9-40. LEACHATE MIGRATION FROM TSF

Concern:

Figure 1: Mine inflow rates from (Jacobs (Australia), 2020)

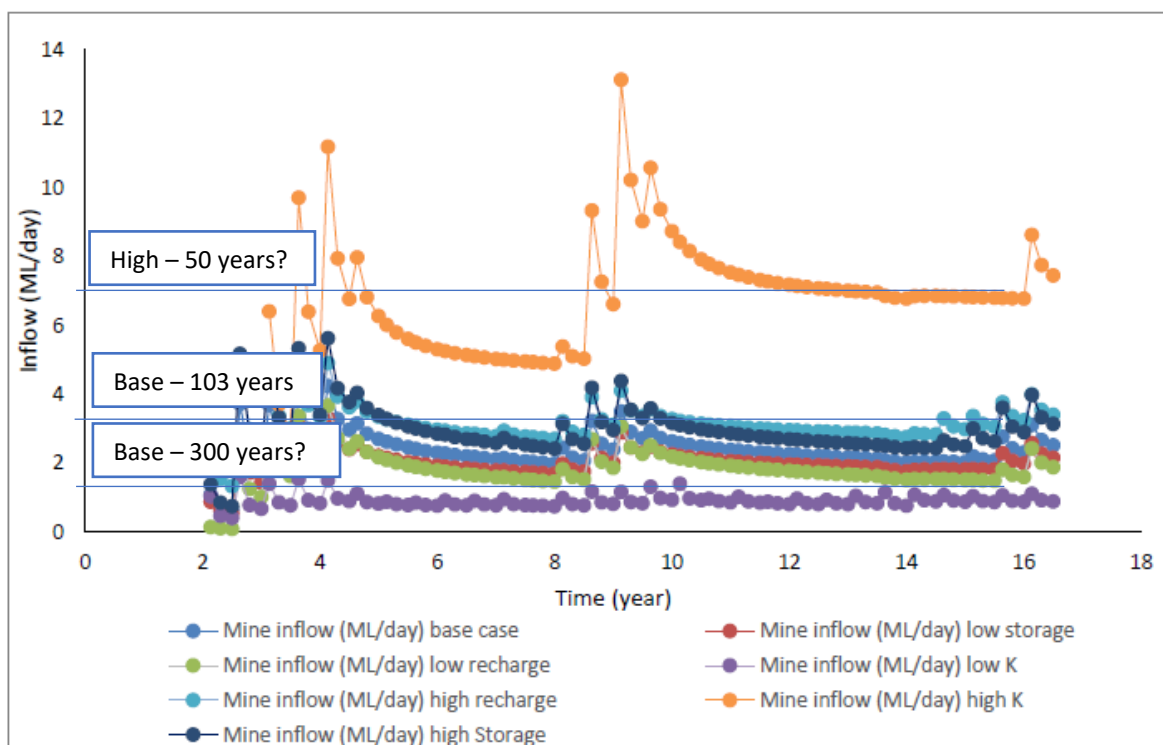
Post-mining, the EIS describes plans to allow a pit to fill with surface water run-off (and rainfall) as well as groundwater influx. The 'base case' rate of groundwater influx is 3 ML/d at the end of mining (year 16). Considering Figure 1, the uncertainty range indicates that it may take 50-300 years for the pit to fill, depending on the connectivity of groundwater with the pit. Groundwater that is not in good hydraulic connection with the pit would largely continue to flow in the same direction as pre-mining. In the case of the TSF area, this may be to the west and southwest (Figure 2).

Figure 2: Pre-mining groundwater contours, showing inferred groundwater flow directions, adapted from (Jacobs (Australia), 2020)

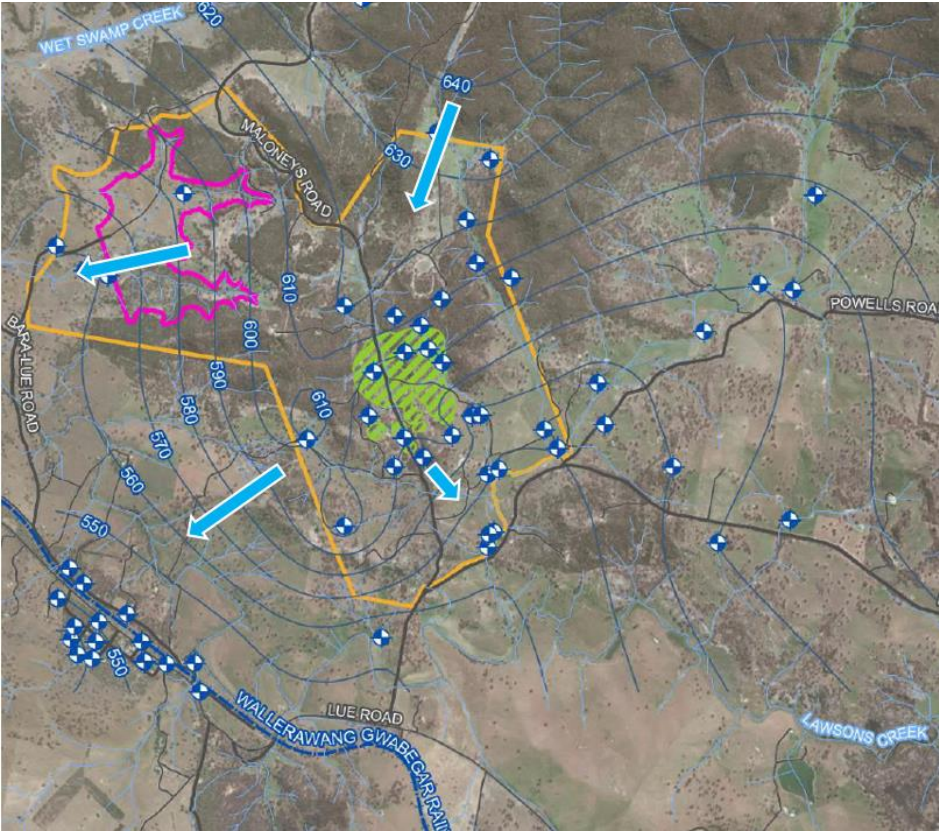
Section 4.7.5.5 (R. W. Corkery & Co. Pty. Limited, 2020, pp. 4-161) states that final pit lake water level will be 566.5-572.5 mAHD under some climate change assumptions. The estimate in the surface water report and the groundwater modelling considers a final level of the pit lake between 571 – 577 mAHD with an average elevation of 574 mAHD (WRM Water and Environment Pty Ltd, 2020, pp. 6-106). If using the lower estimate of the final pit lake water level under some climate change assumptions, the inferred groundwater flow changes are shown in Figure 2 and Figure 3.
